BULLETIN NO. 2

Rocky Hill Intermediate School – Phase 2, Rocky Hill, CT

Rocky Hill Intermediate School Pre-Bid RFI Log – Bulletin 002
Updated: March 21, 2018

SECTION DR9 REVISED

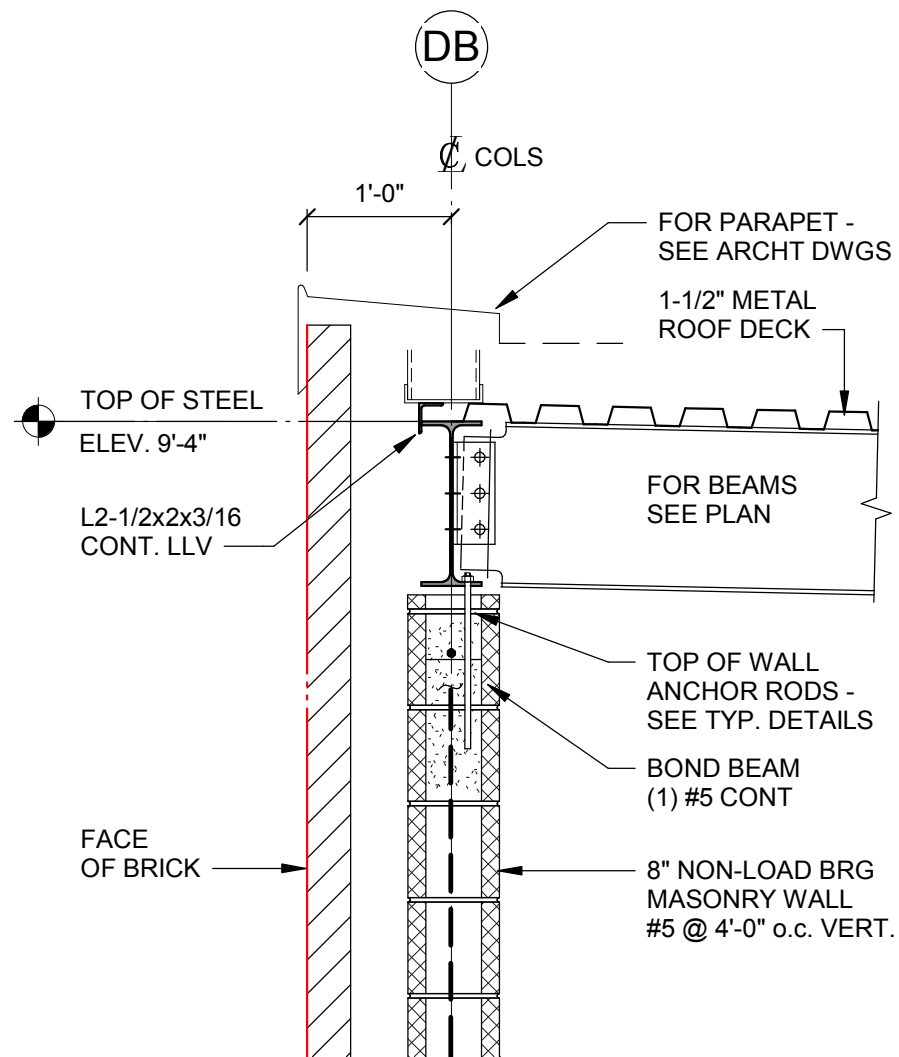
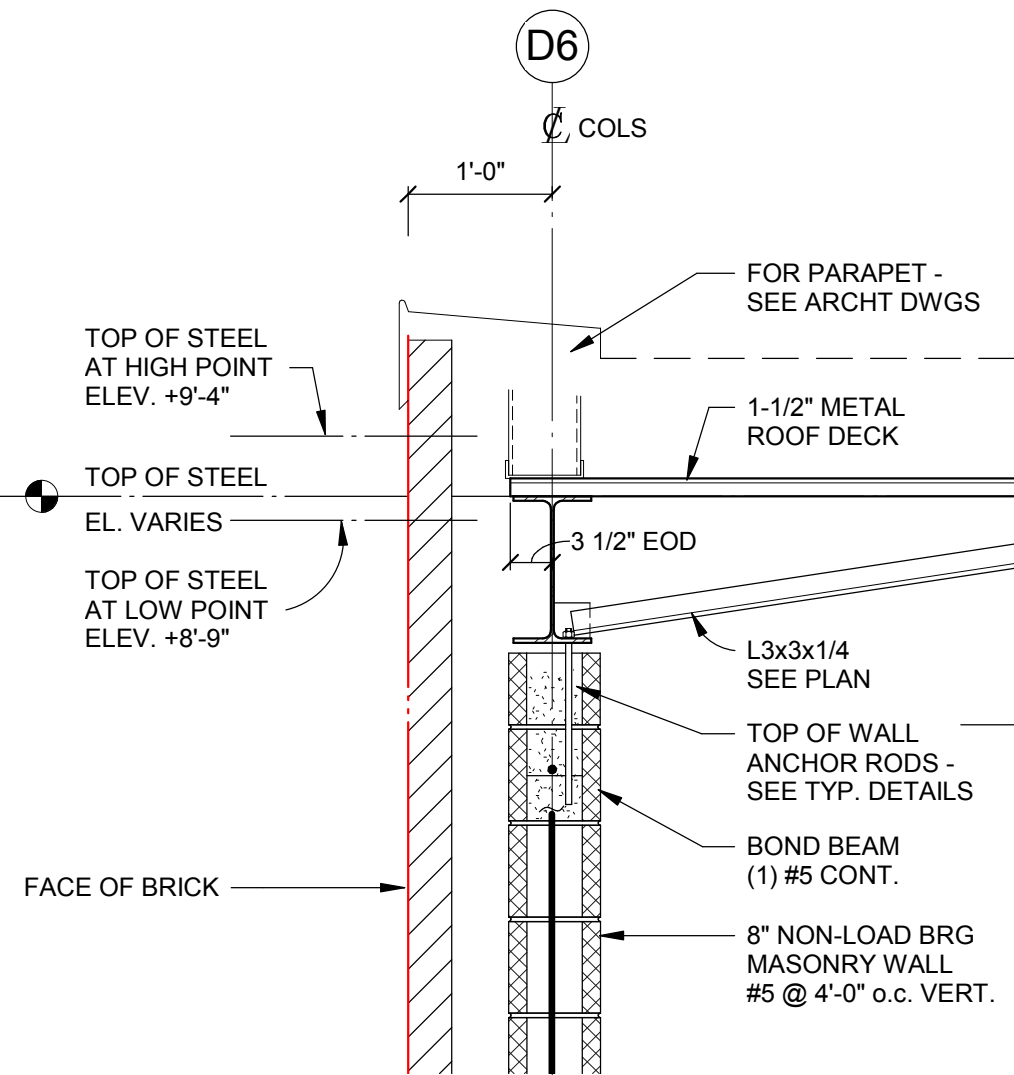
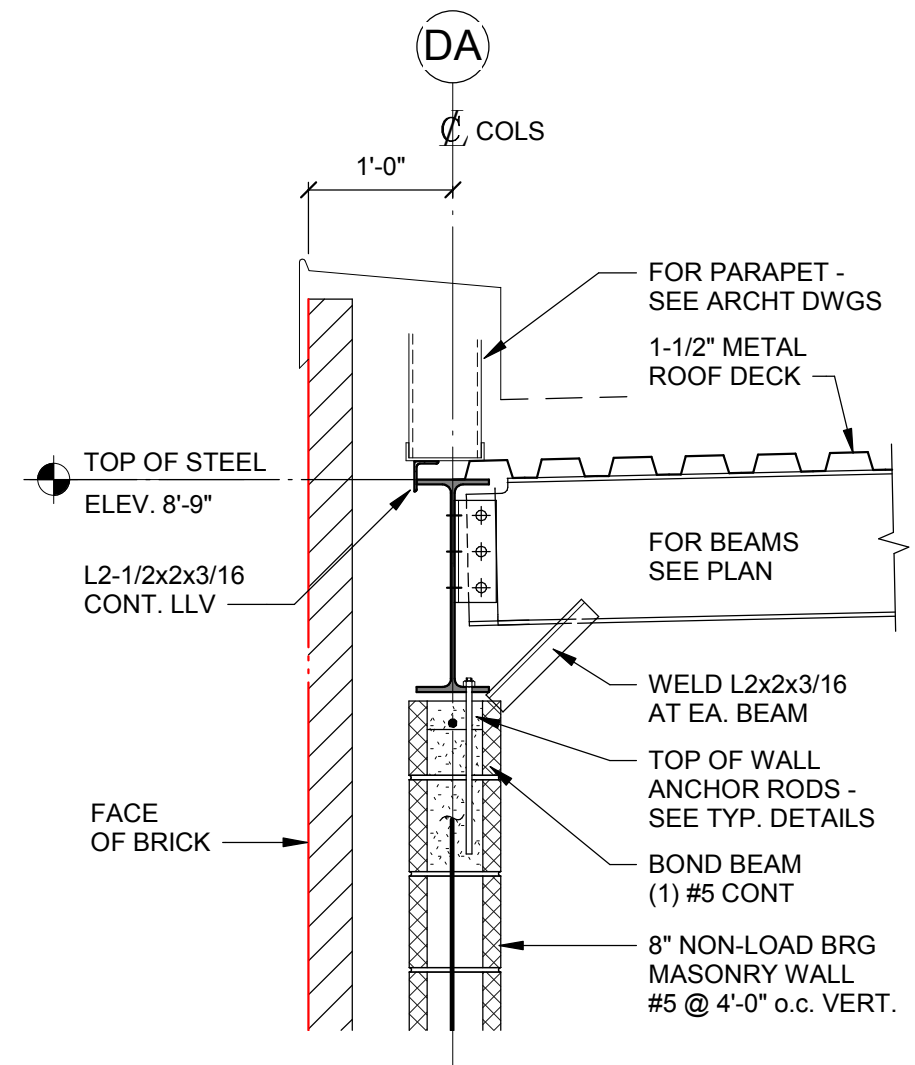
See SKS-2.03 for revised SECTION DR9, DR10, DR11, and DR12 (similar to).

SEE ORIGINAL SECTION DR9 / S6.04 FOR BALANCE OF DETAIL AT OVERHEAD DOOR BELOW

NOTE - SECTION DR12 / S6.04 REVISED SIMILARLY TO DR10

SECTION B2 REVISED

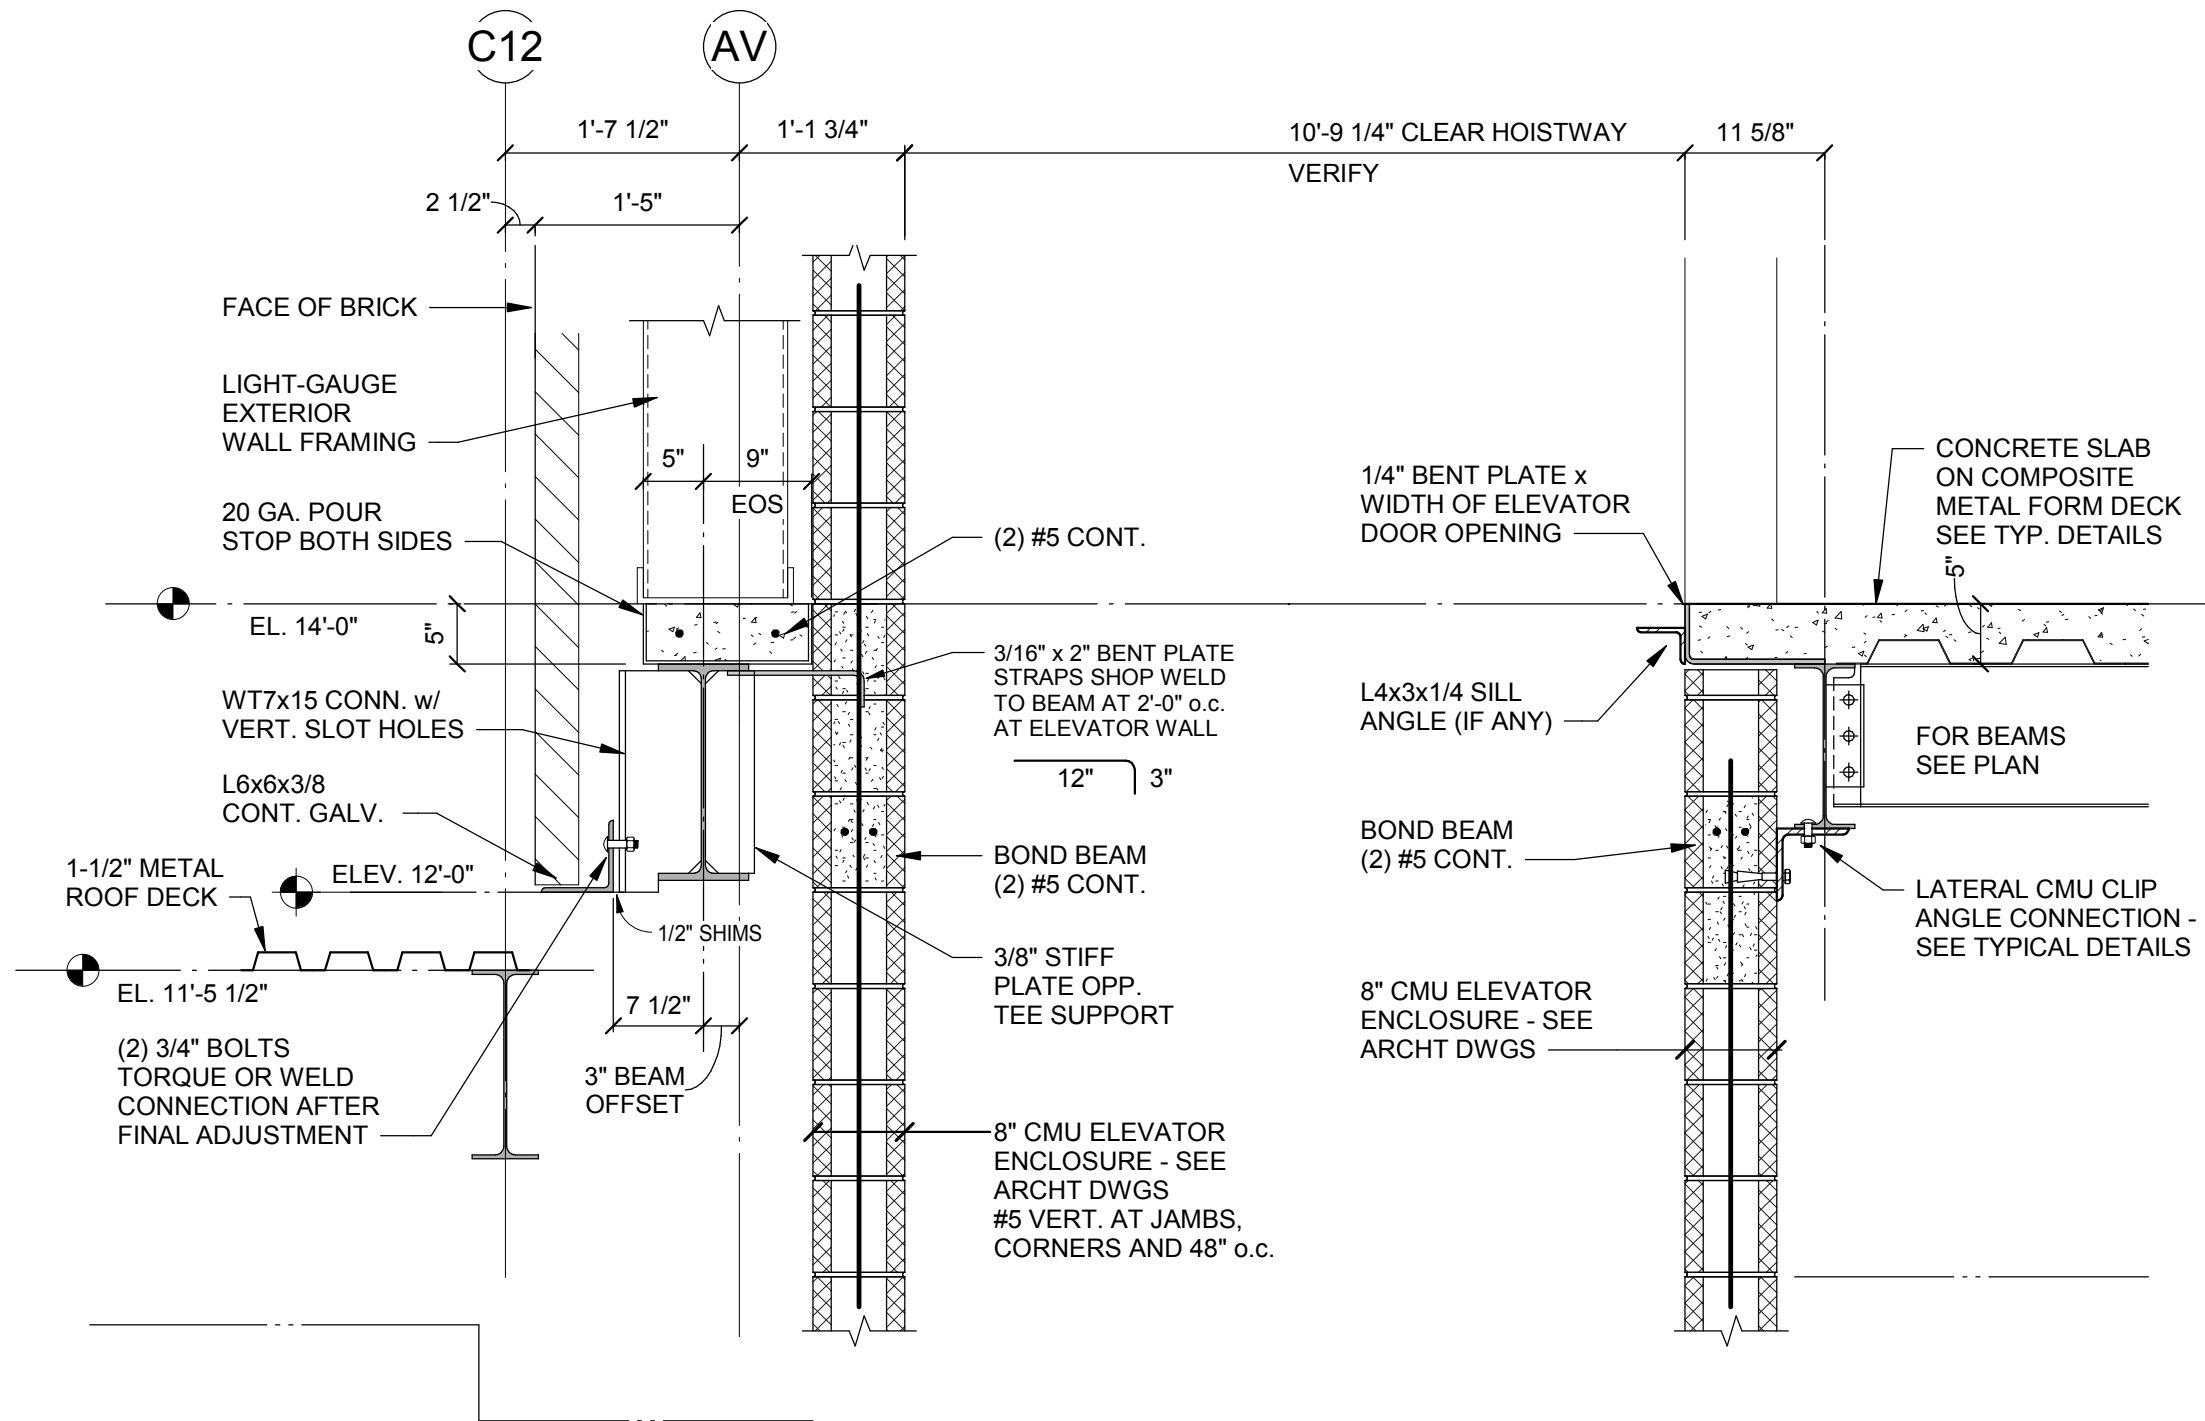
S2.01 UPPER LEVEL FRAMING PLAN AREA A

See revised section B2 on SKS2.04.
